### CLARIFICATION #4.3

**PROCUREMENT OF PLANT DESIGN, SUPPLY, DELIVERY, INSTALLATION, TESTING AND COMMISSIONING OF LOT 1: 400 kV RATMATE SUBSTATION AND WORKS AT LAPSIPHEDI AND NEW HETAUDA SUBSTATIONS, LOT 2: 400 kV NEW BUTWAL SUBSTATION, LOT 3: 400 kV NEW DAMAULI SUBSTATION**

**Ref No: MCA-N/ETP/CB/004**

**Issued on: 3 August 2023**

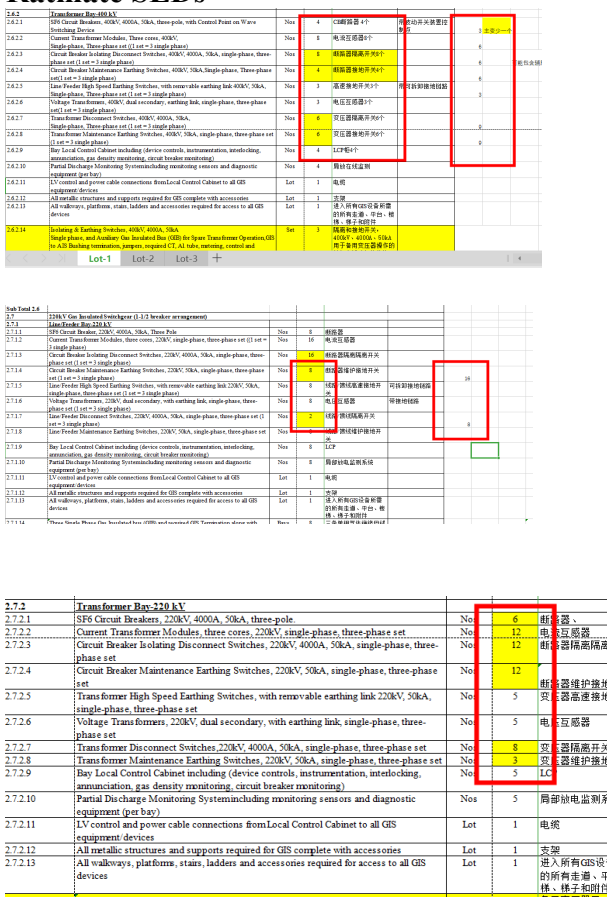
747.	<b>Chapter 10, Control and Relay Panel</b> <b>S2 TS CRP Port RATMATE Substation.</b> <b>2.5 Bus Protection</b>	For Busbar Protection scheme for 220 kV & 400 kV Voltage level shall be redundant i.e. whether we have to provide Bus differential relay main 1 and main 2 relays of different manufacturer. Busbar Protection scheme for Substation is considered as Centralized Busbar Protection scheme.	The requirement of the manufacturer will be determined during detailed engineering subject to the approval of Engineer. Busbar Protection scheme will be centralized such that it is ensured that tripping can happen on the faulted bus even if one of the system is out of service
